DOS RIOS CONCRETE DRYING BED PILOT PROJECT
Solicitation Number: B-18-015-JAM
Job No.: CAP3318460

ADDENDUM 2
September 6, 2018

DOS RIOS CONCRETE DRYING BED PILOT
SLUDGE BED C-2 & C-3
STRUCTURAL PLAN

SLUDGE BED C-2
& C-3 PLAN VIEW
SCALE: 1/8"=1'-0"

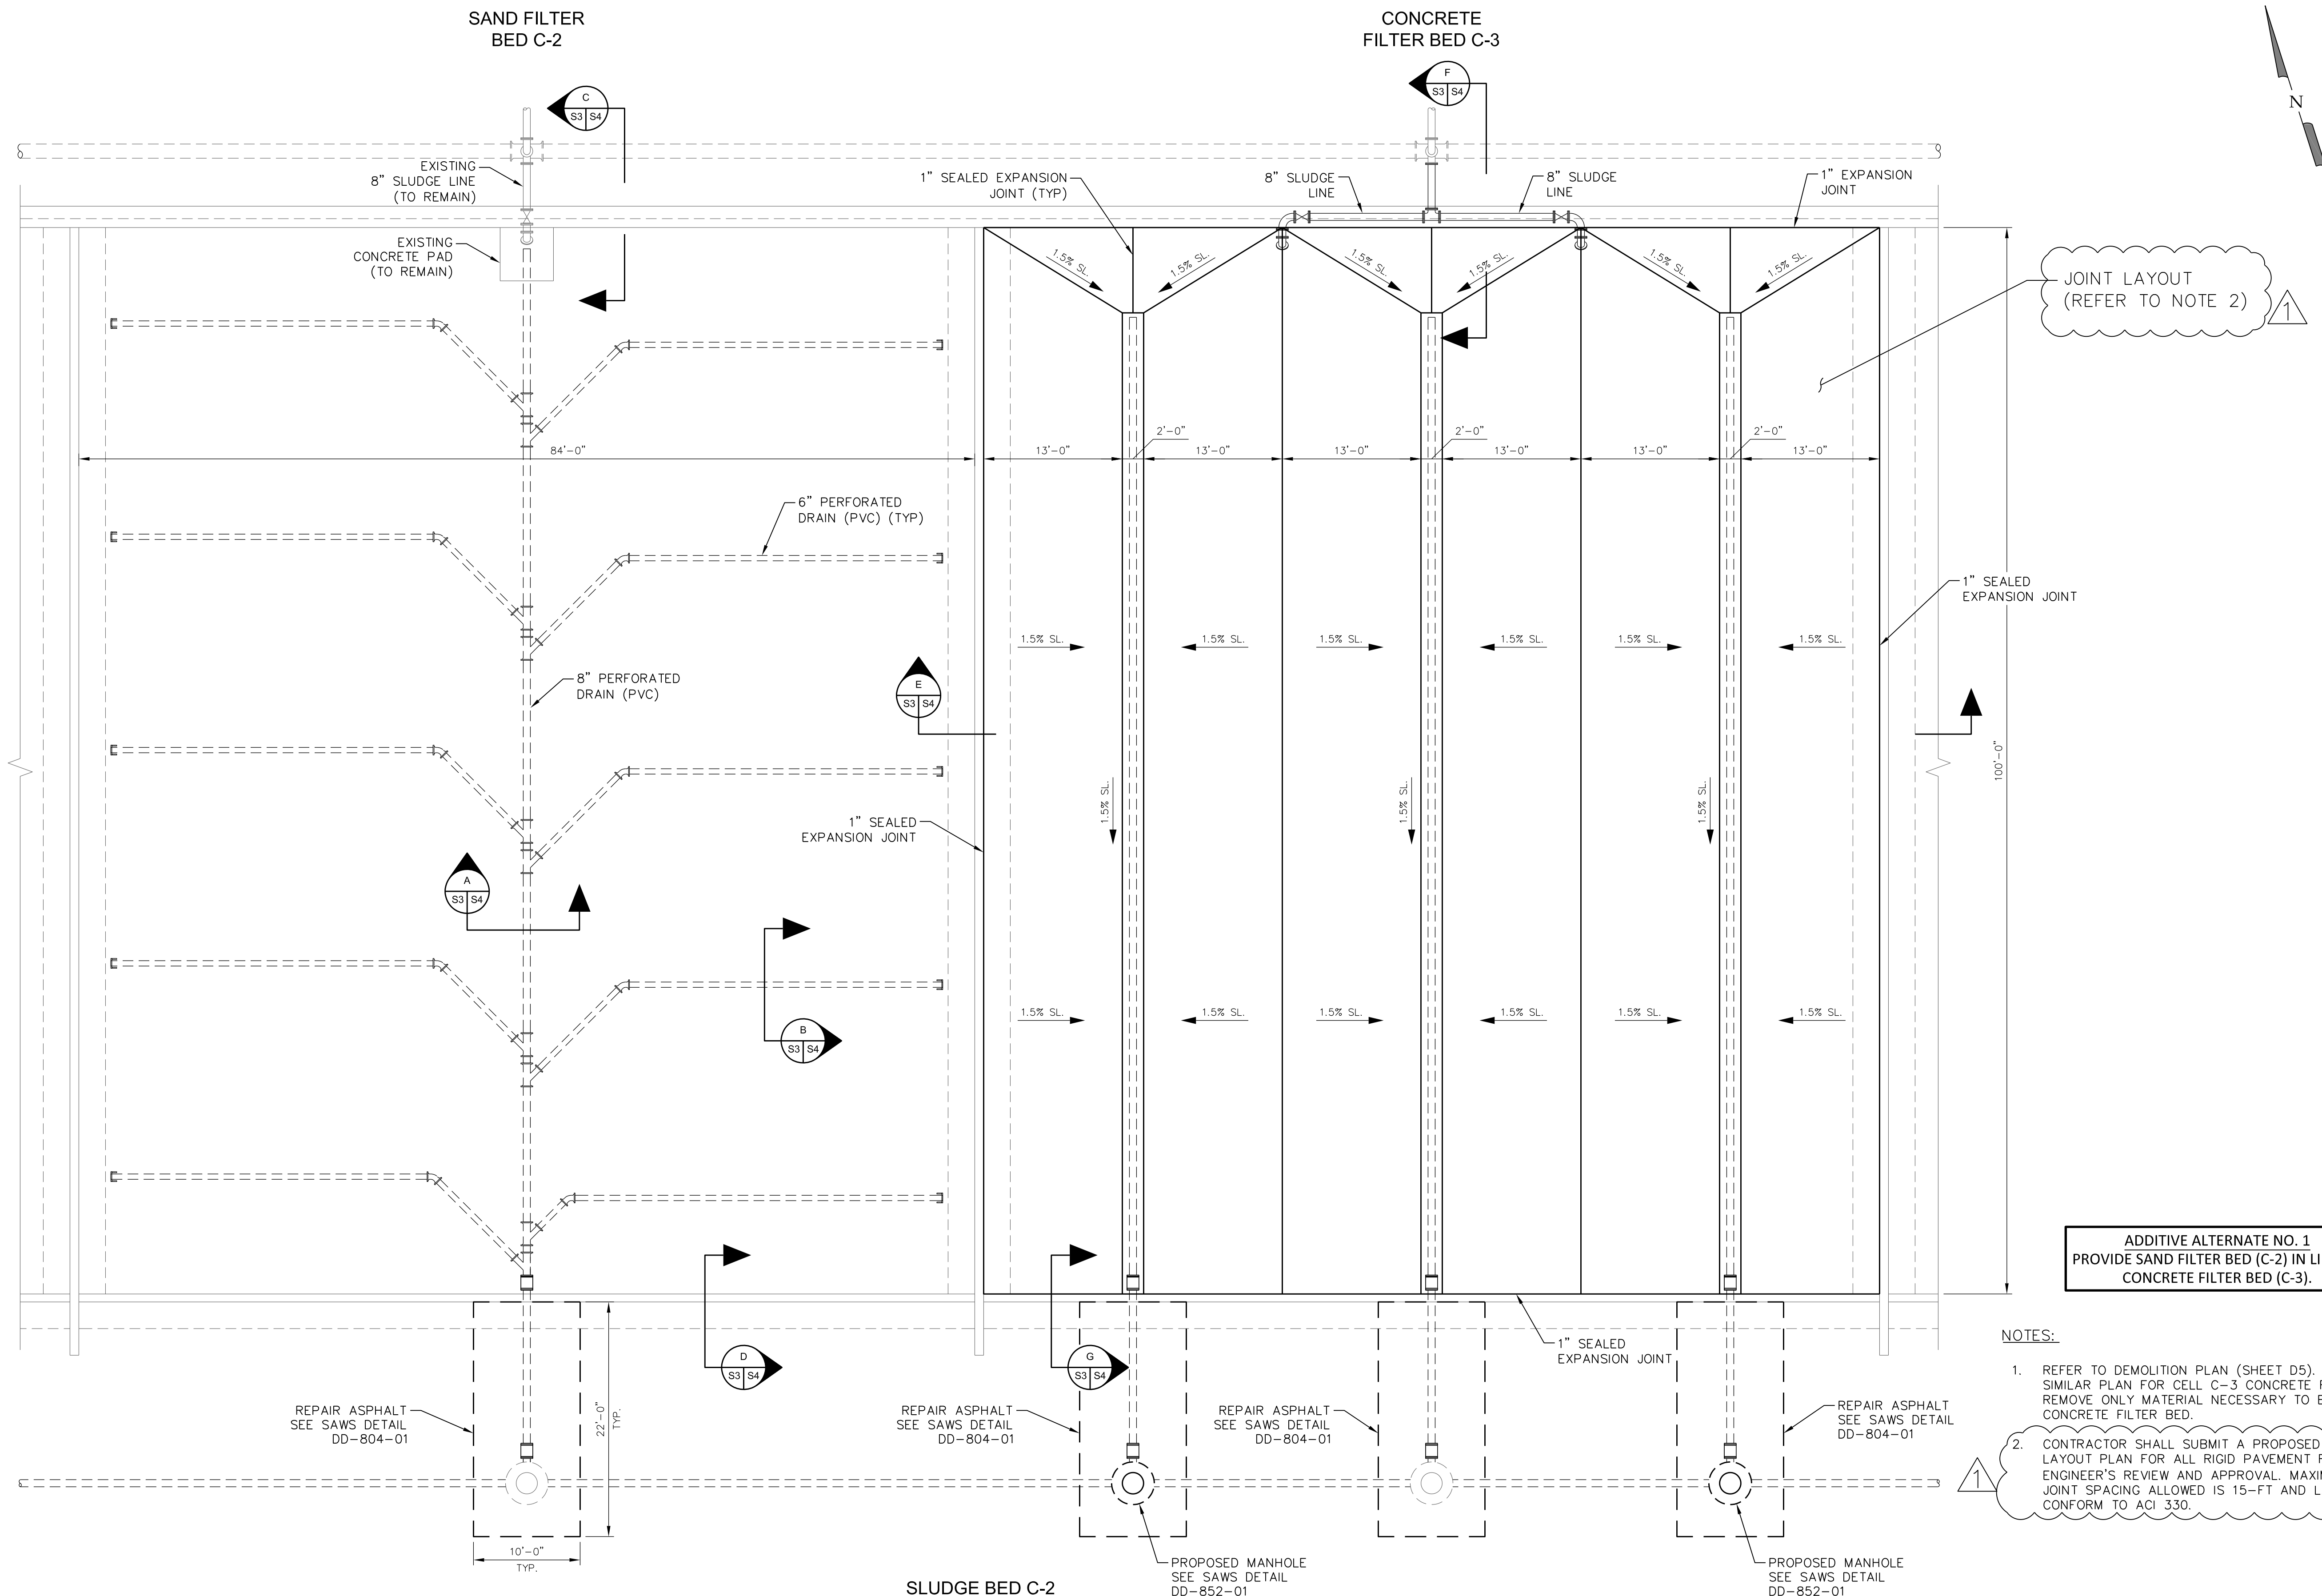
Response: The clay material must be imported.
- 5. Question:** Are there any construction/contraction joint required or allowed in the Base Bid C-3 option?

1. Plan Sheet S-3: Sludge Bed C-2 & C-3 Structural Plan shall be removed in its entirety and replaced with the attached.

Response: Refer to attached plan S3, sheet #8 (Addendum No. 2).
- 6. Question:** Base Bid Item No. 1 is for one each? Which one? Does this item include both drying beds C-2 and C-3?

JOINT LAYOUT
(REFER TO NOTE 2)

- NOTES:
- REFER TO DEMOLITION PLAN (SHEET D5). FOLLOW SIMILAR PLAN FOR CELL C-3 CONCRETE FILTER BED. REMOVE ONLY MATERIAL NECESSARY TO BUILD NEW CONCRETE FILTER BED.
 - CONTRACTOR SHALL SUBMIT A PROPOSED JOINT LAYOUT PLAN FOR ALL RIGID PAVEMENT FOR ENGINEER'S REVIEW AND APPROVAL. MAXIMUM CONTROL JOINT SPACING ALLOWED IS 15'-FT AND LAYOUT MUST CONFORM TO ACI 330.
